Case Number: BOA-19-10300084

Location: 225 E. Mistletoe Ave

Request

A request for an appeal of the Director's decision related to issuance of a building permit for an accessory structure with accessory detached dwelling unit; UDC Section 35-310.01(b). Generally, UDC Section 35-A101: Definitions and Rules of Interpretation, and UDC Section 35-371(b)(6): Accessory Detached Dwelling.

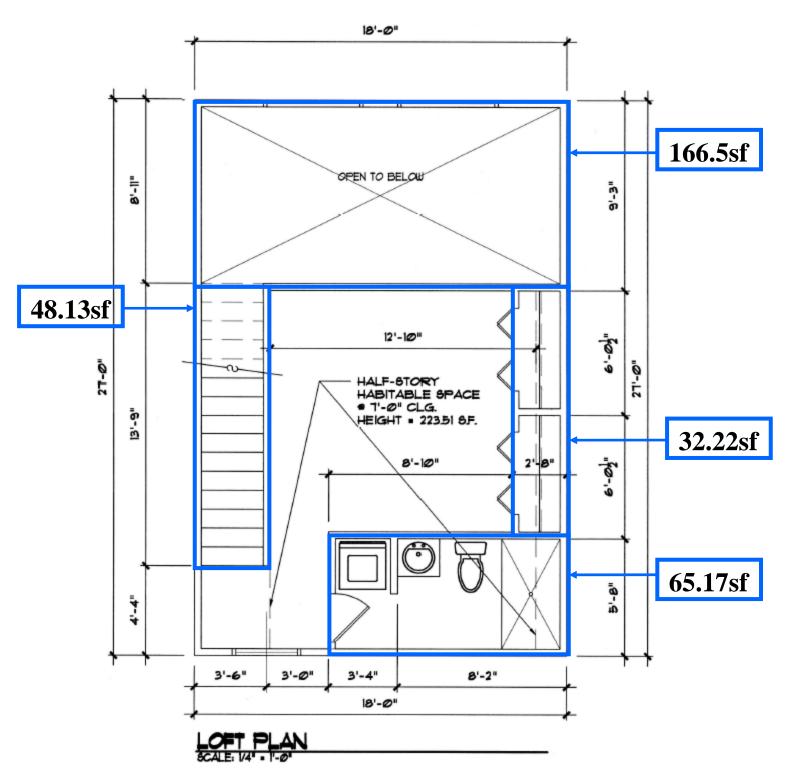
The codes clearly recognize that habitable area and floor area are not one in the same. To calculate the habitable area of the uppermost floor, the area of the bathroom, toilet room, closet, hall and storage/utility spaces are excluded from the floor area.

The habitable area of the uppermost floor calculates to be 486sf-166.5sf - 48.13sf - 32.2sf - 65.17sf = 173.98sf which is well under the allowable floor area of 243sf.

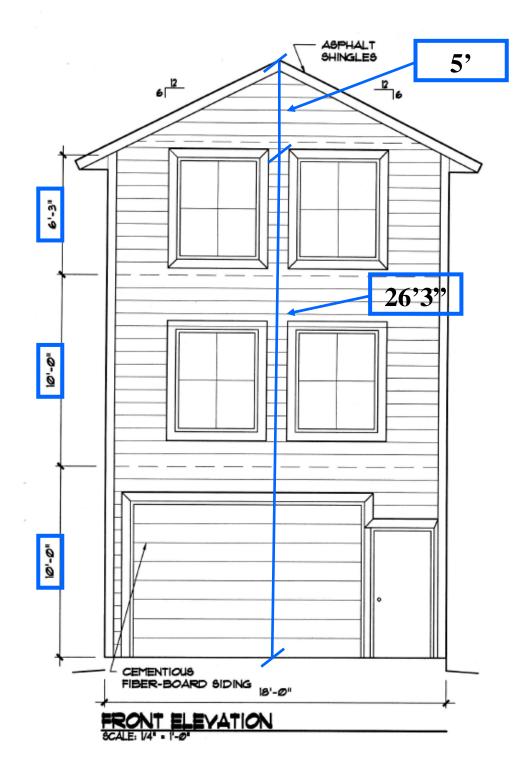
The UDC definition of height, again, states that the height shall be measured from the average elevation of the finished lot grade at the front of the building to the average height between the plate and ridge of a gable roof, in this case. The average height between the plate and ridge of the gable roof is determined by taking the total height and dividing by two. The measurement of 5ft between the plate and the top of the ridge was taken from the plans. $5^{\circ}/2 = 2^{\circ}6^{\circ}$.

Total Height = $10^{\circ} + 10^{\circ} + 6^{\circ} 3^{\circ} + 2^{\circ} 6^{\circ} \text{ft} = 28^{\circ} 9^{\circ}$ which is well under the maximum allowable 35' height. Even if the total height was measured to the top of the ridge, the height would be 31'3" and would still not exceed the maximum allowable height of 35ft.
